15K "ES" BOP

Prepared by:	TOT 15,000psi Working Pressure "ES" BOP	<b>PSB-050</b> February 2001 Page 1 of 3
Approved by:

Pipe, Slip, and Blind Rams on the Quad: See drawing ES46-T011-1

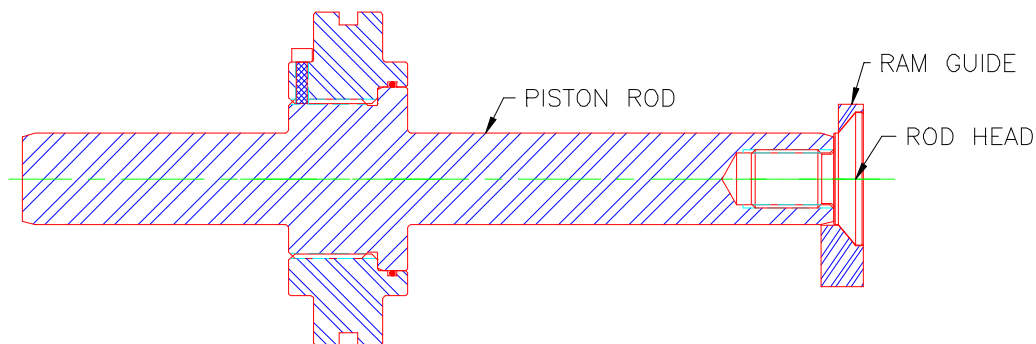
TOT will replace all of the rod heads with a new redesigned rod head and the addition of a ram guide on certain actuators. This change effects every "ES" actuator. The blind, slip, and pipe actuators on the quad require a new piston rod head and the ram guide. The shear actuator requires a new Rod Head. Actuators on the shear seal require a ram guide and new piston rod, and the pipe slip requires a new piston rod head.

Assembly of the Rod Head to the piston rod includes the use of Loctite 242 (Blue) for proper performance. Two drops of this Loctite on the piston rod threads will ensure adequate adhesion.

New Rod Head part number 9905-2833 rev. C

New Ram Guide part number 2001-0024 rev. -

Shear Seal Actuator: See Drawing ES46-T011-3  
New Piston Rod part number 9905-2926 rev A  
New Ram Guide part number 2001-0025 rev. -

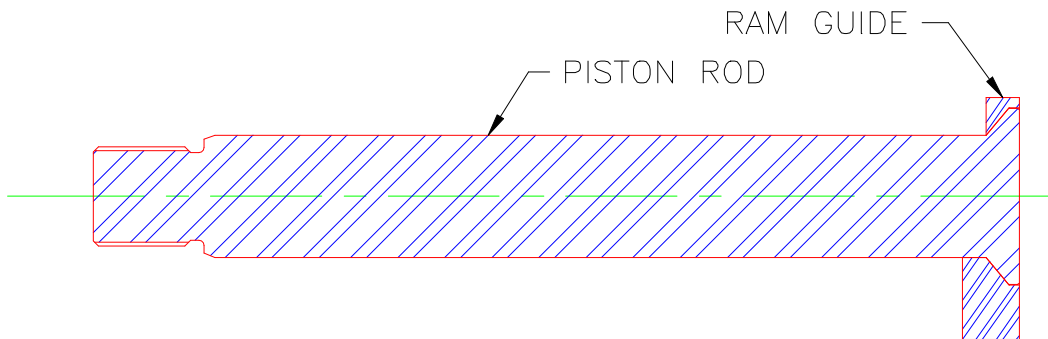
The piston rod must be replaced for this unit along with the addition of the ram guide.  
The shear seal does not have a rod head like the other actuators the design on the piston rod is such that it is not required.
